Lynn Lake Gold Project: MacLellan Mine Plan Amendment Notice of Alteration / Notice of Change

Federal Information Request Responses – Round 2

September 19, 2025

Response to IAAC NOC IR-14-2

TITLE
SEEPAGE COLLECTION SYSTEM PLAN AND DETAILS

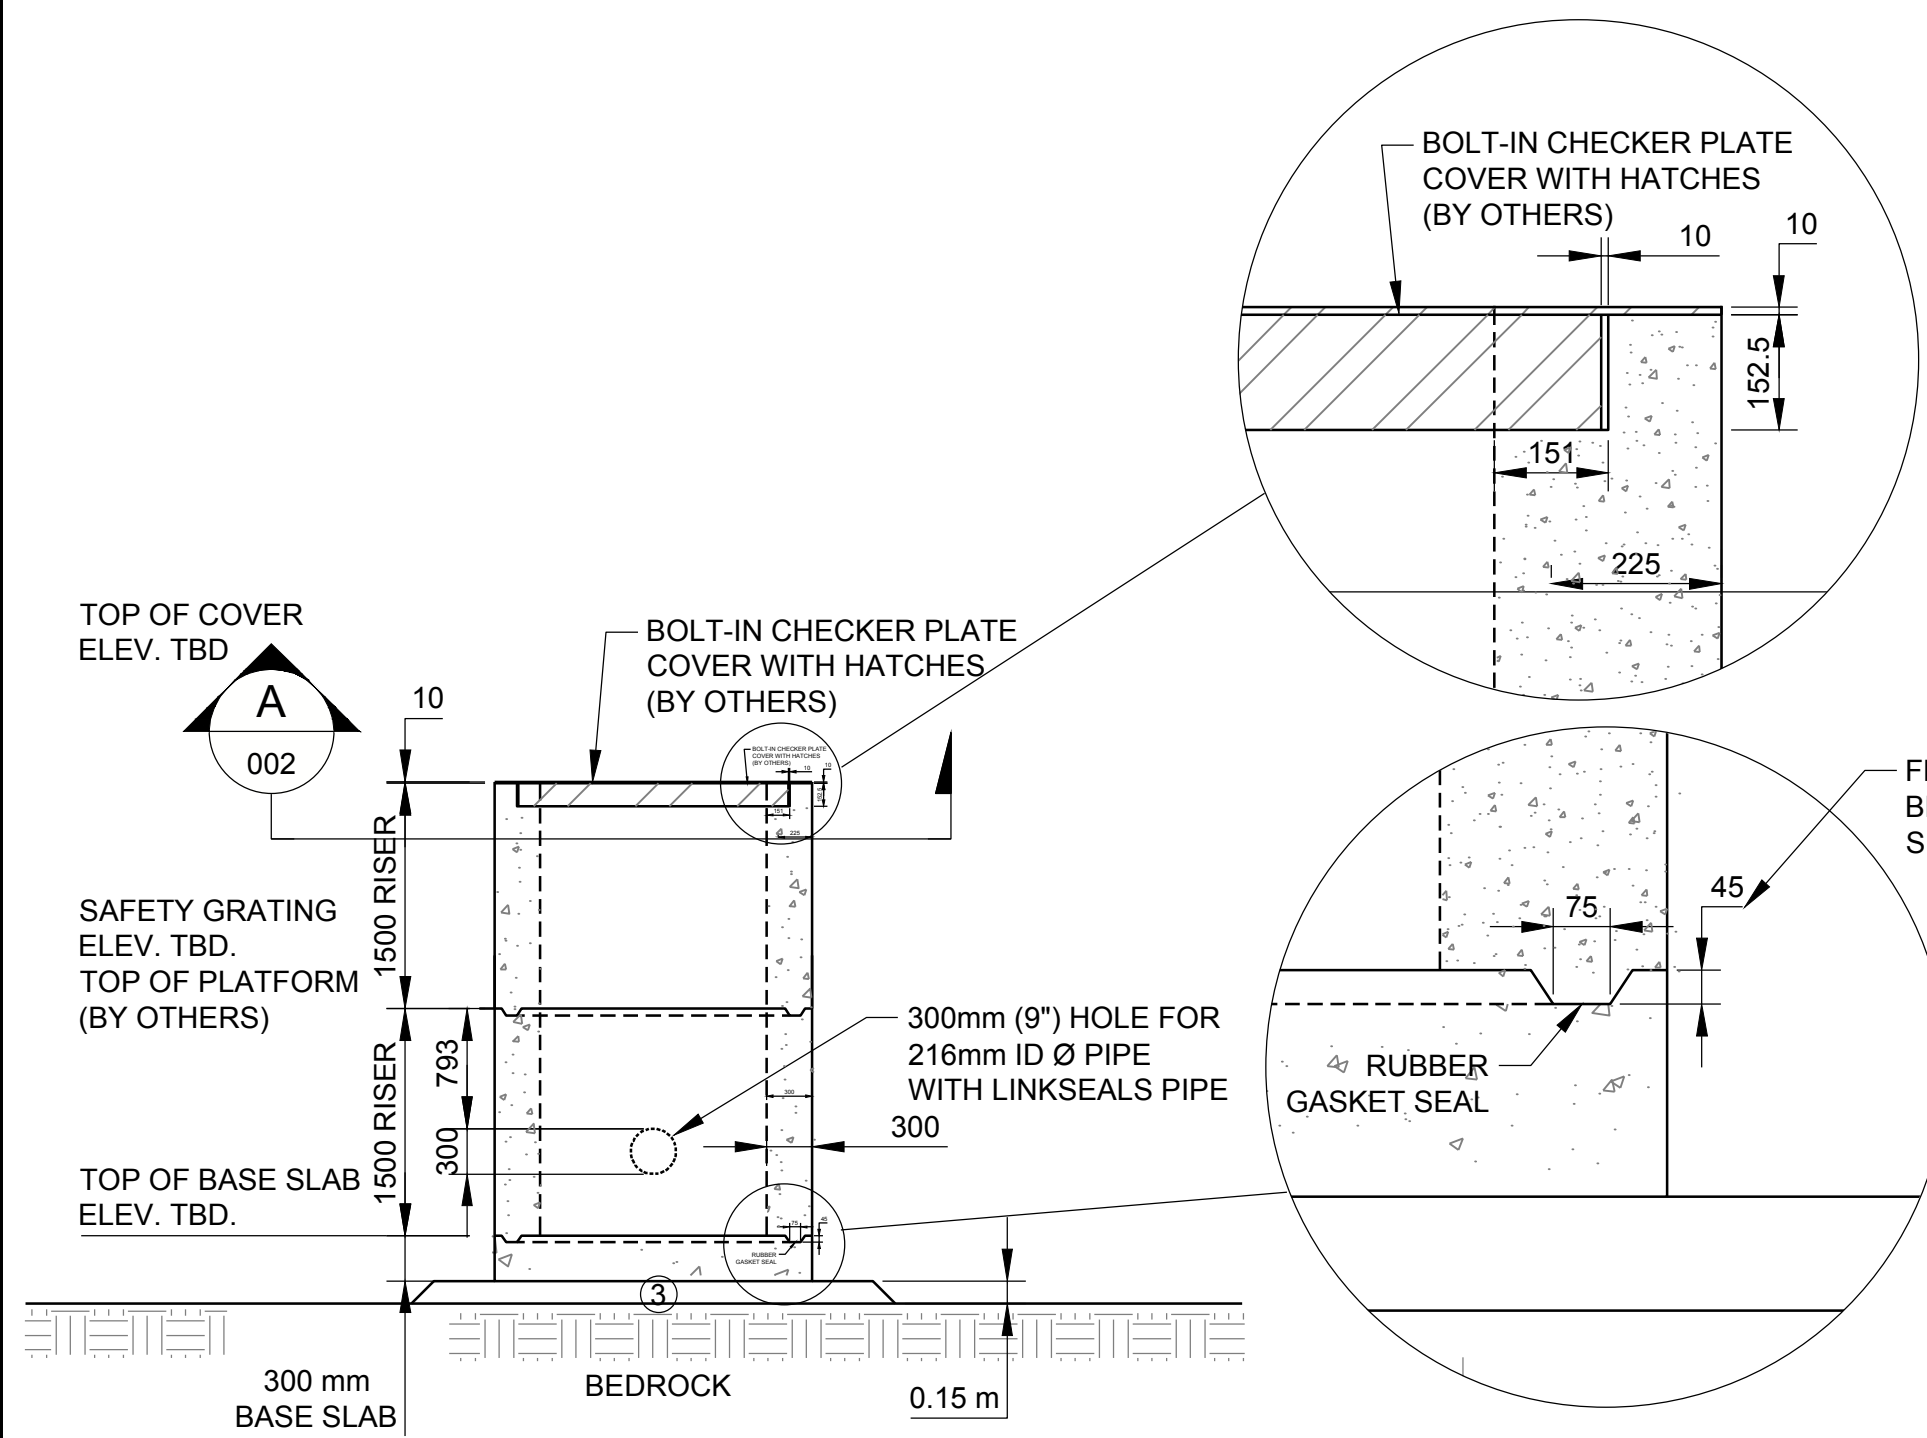
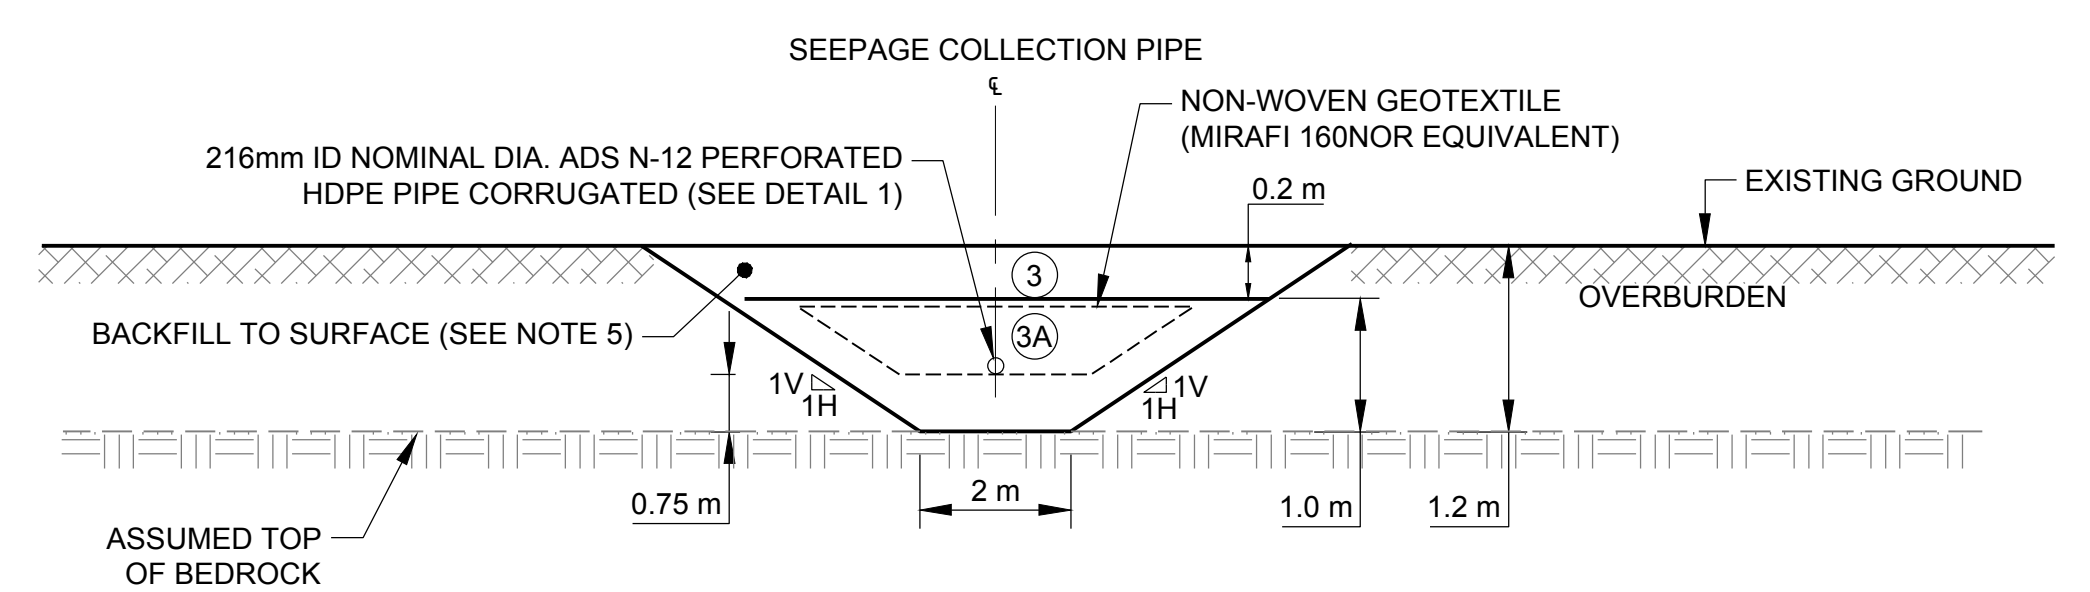
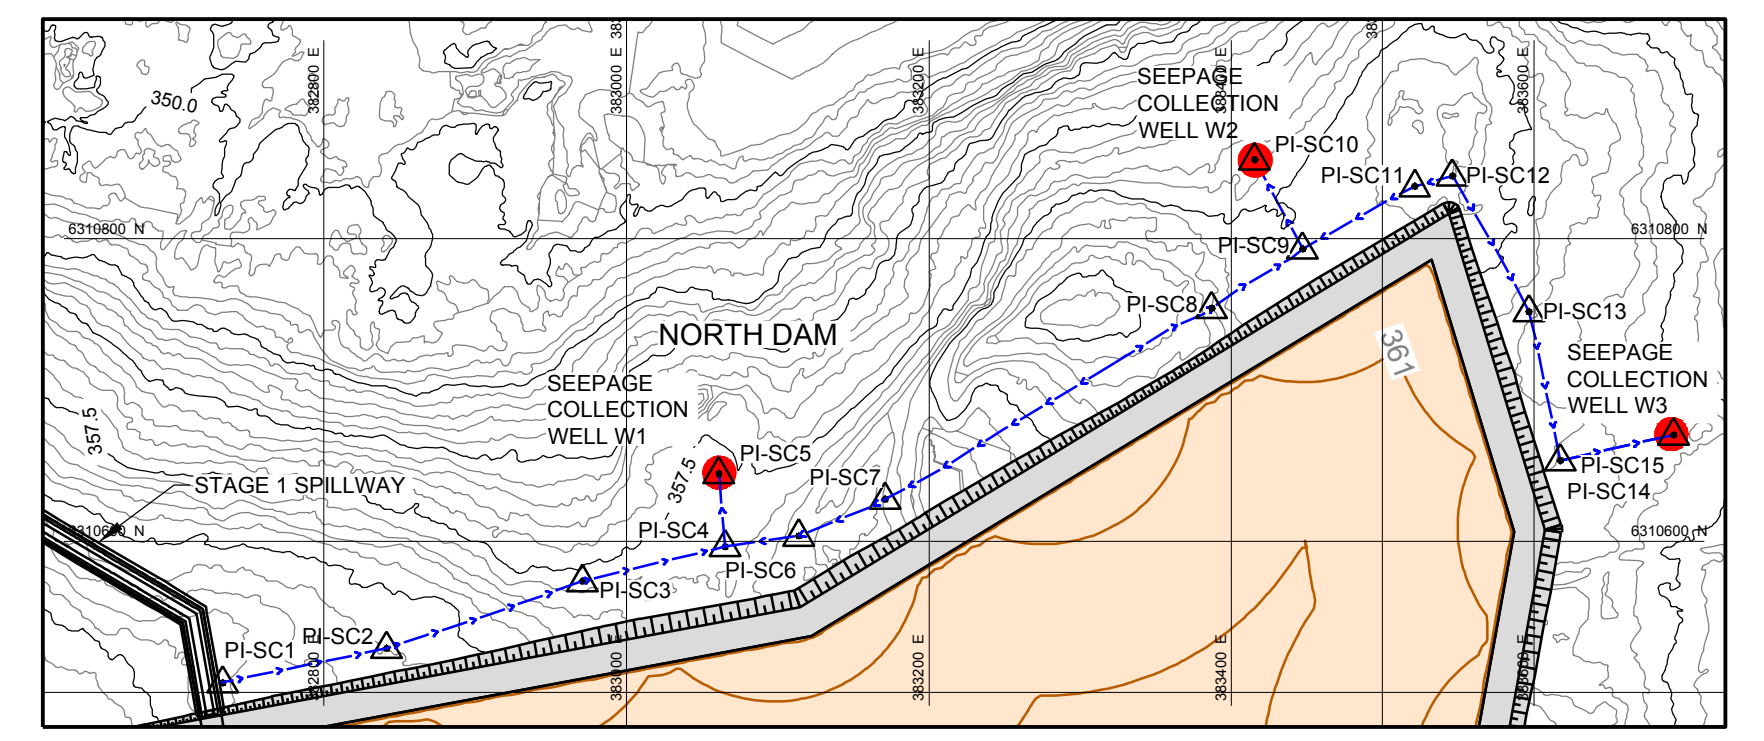
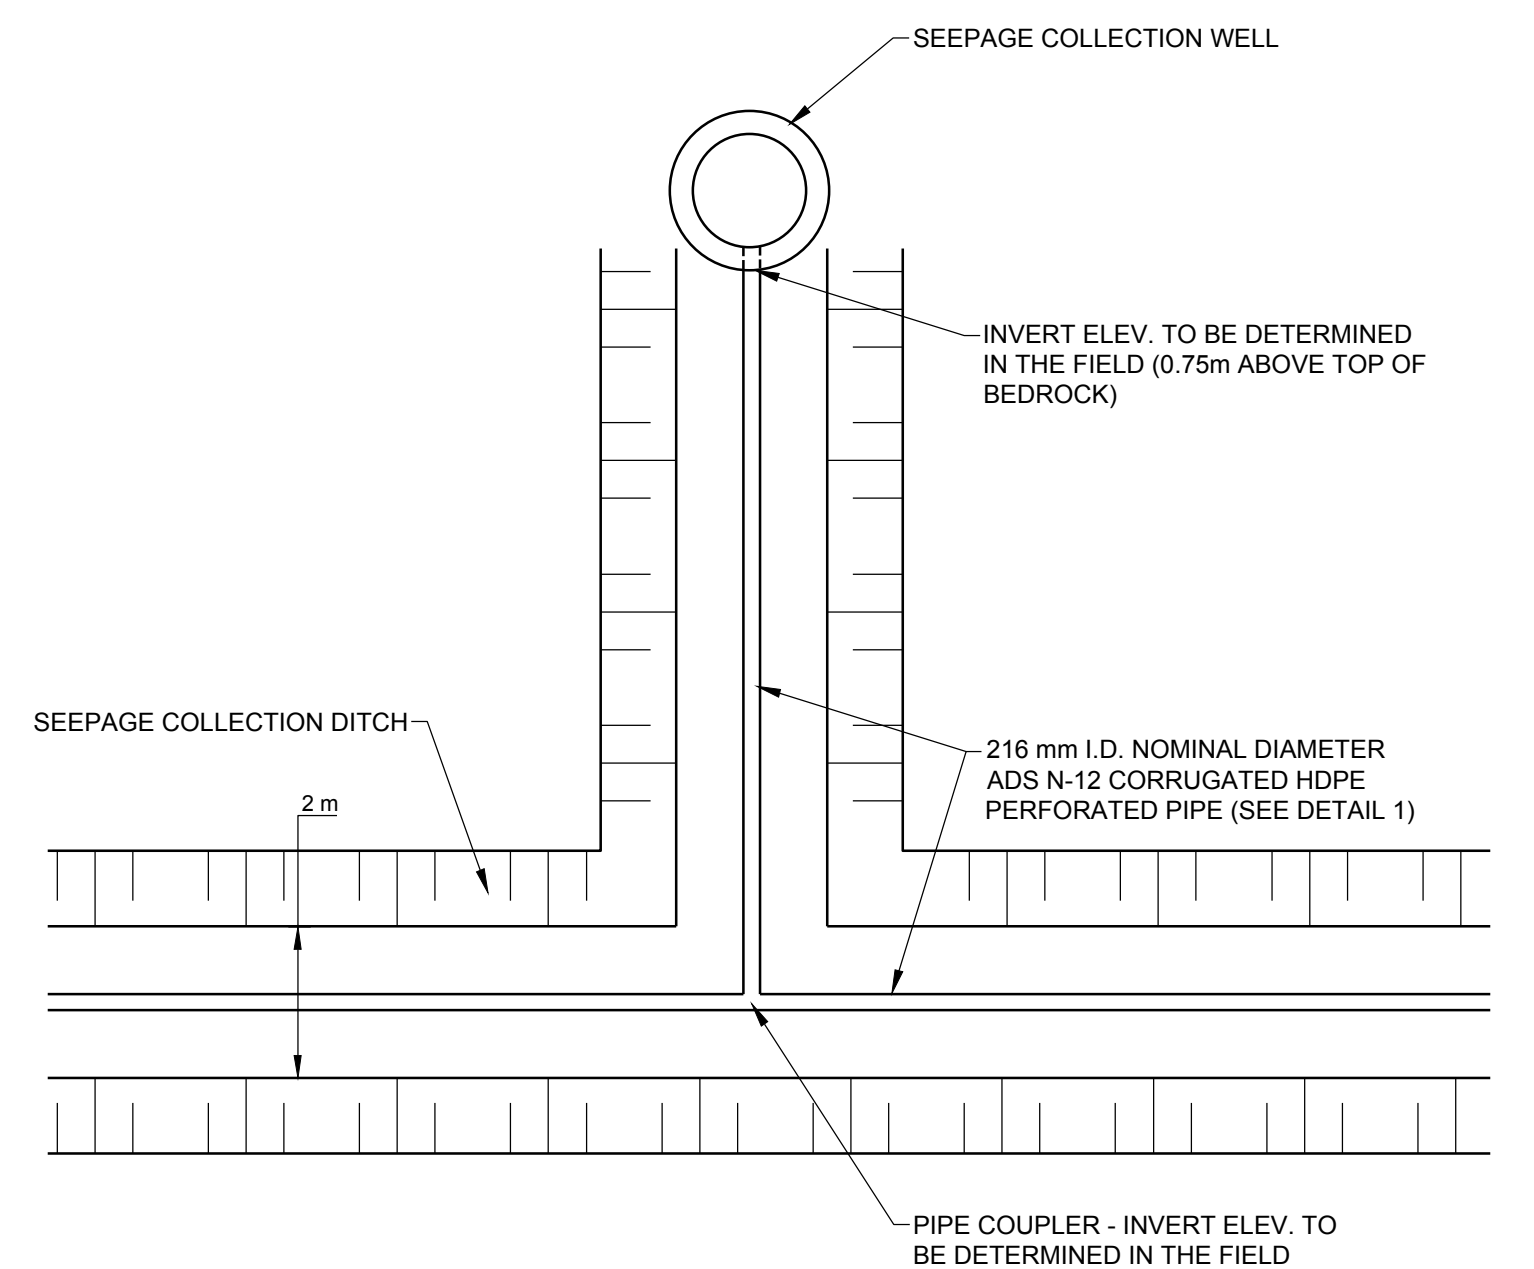
ID:	NOC IR-14-2
Topic	Water quality Mitigation Measures, Fish and Fish Habitat
Expert Department or Group:	ECCC IAAC
NOA/NOC reference:	Section 4.0 – Conclusions Appendix G – Surface Water Quality Figures Surface Water Management and Monitoring Plan (Version 0 – January 2025)
Information Request:	<p>IAAC Follow-Up Questions:</p> <p>a) Please describe which of the mitigation measures in Table E-1 were included in the modelling presented in the NOC that mitigate surface water impacts to the three water bodies where changes in magnitude are predicted in Table 3.24.</p> <p>b) Please explain why the specific additional adaptive management strategies you reference in section 3.3.5.3 (which references the measures on pg. 89-90 of the Jan 30th version of Surface Water Management Plan) can be relied on to effectively reduce residual water quality effects in Table 3.24 of the NOC to those predicted in Table 9-36 of the EIS.</p> <p>c) Which of these measures mentioned above (or any others) could be implemented proactively instead of relying on adaptive management. If none can be implemented proactively, please explain why.</p>

ID:	NOC IR-14-2
	<p>streams. This reduction of seepage migration into the water bodies would reduce residual water quality effects.</p> <p>c) Discussions with engineers involved in the detailed design of the TMF and MRSA, have identified that there will be three seepage collection wells with a subsurface drain around the TMF as well as grout curtains installed from the top of bedrock to a depth of between 10 and 15 m through the upper fractured bedrock. Drawings are attached to this response. These five features – which were not modelled within the 3D groundwater model – were simulated with a 2D seepage model and show that the grout curtain addition halves the seepage towards the water bodies (in comparison to model results without the grout curtain in place).</p> <p>With the committed additions to the TMF and MRSA design, the implementation of the Management and Monitoring Plans (for early detection of potential issues requiring additional mitigation) and the ability for grout curtains to be deepened, pump-back wells to be installed, and/or other mitigative measures, the water quality effects to Payne Lake, Minton Lake, and Tributary KEE3-B are not predicted to be altered from the approved project effects.</p> <p>It is important to note that Alamos acquired MonitorPro Web by EHS Data (MonitorPro) as an environmental data management software designed to streamline regulatory compliance and environmental monitoring. MonitorPro is one of our mitigation tools, enabling proactive environmental data management by allowing us to react quickly based on real-time monitoring results and imported environmental sample data such as water, air, vibration, noise, and wildlife. As soon as laboratory or field data is submitted, the system imports the results, calculates and compares them against applicable regulatory limits, internal thresholds, and/or modelled predictions, issuing automated alerts and warning notifications when results approach or exceed set criteria. This real-time comparison allows potential exceedances or trends toward non-compliance to be immediately identified, giving us the ability to implement timely mitigation measures, amend or enhance existing practices, and apply adaptive management strategies before non-compliance occurs.</p> <p>With its web-based interface, MonitorPro provides accessible, accurate, and actionable data insights that builds a robust basis for continuous improvement in environmental performance.</p> <p>In addition, the Adaptive Management Framework within the Management & Monitoring Plans was developed with staged triggers to accommodate varying levels of concern and a diversity of actions. This allows timely and informative responses to be initiated before high impact thresholds are triggered. We have used groundwater quality trend analysis as the first trigger for groundwater, which is an early warning tool to determine potential for triggering subsequent thresholds. This means that a change in trend would trigger a review of data even if it is a meteorological effect, which allows early detection of changing conditions.</p>
